# SERVICE BULLETIN

| Classification:<br>BT15-015a | Reference:<br>NTB15-048a | Date:<br>December 15, 2016 |

## 2014-2017 ROGUE; VIBRATION IN STEERING WHEEL OR PASSENGER FRONT SEAT AT IDLE

**APPLIED VEHICLE:** 2014 – 2017 Rogue (T32)

Figure 1

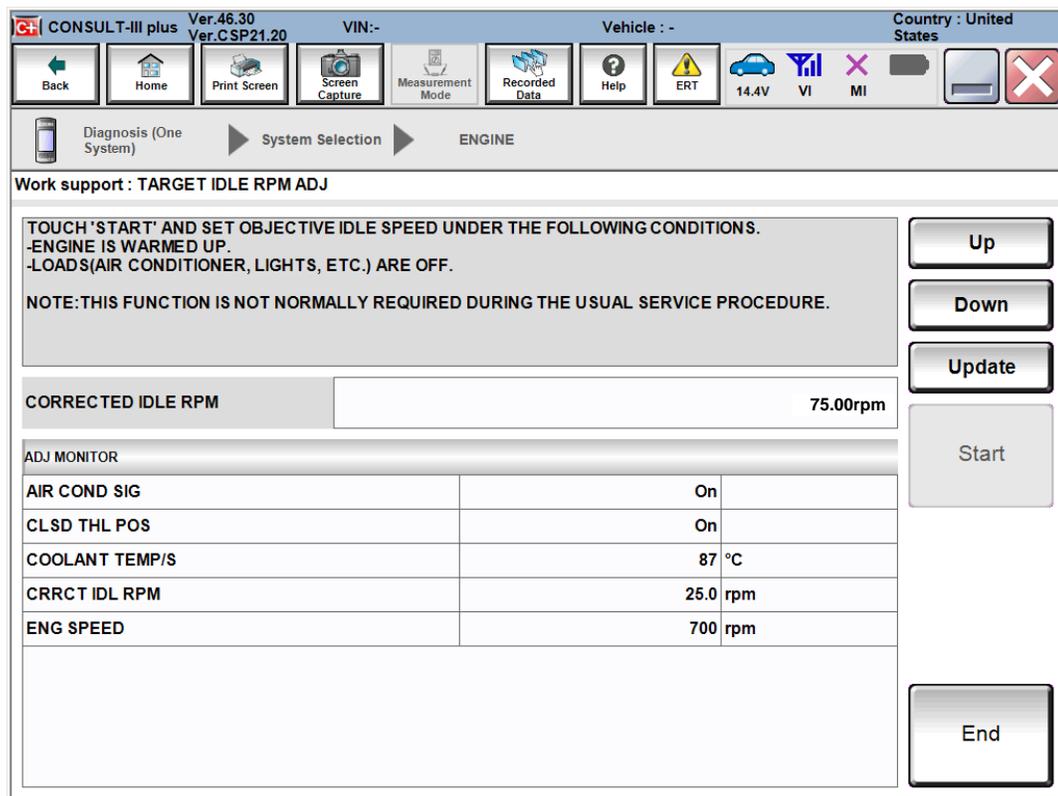
1. With the engine and transmission at normal operating temperatures, and the transmission is in Drive (D) and at idle:
  - Increase the engine target idle by:
    - With Cloth Interior, increase 75 rpm
    - With Leather Interior, increase 62.5 rpm

**NOTE:** Example of CONSULT-III plus screen for target idle adjustment shown in Figure 1.
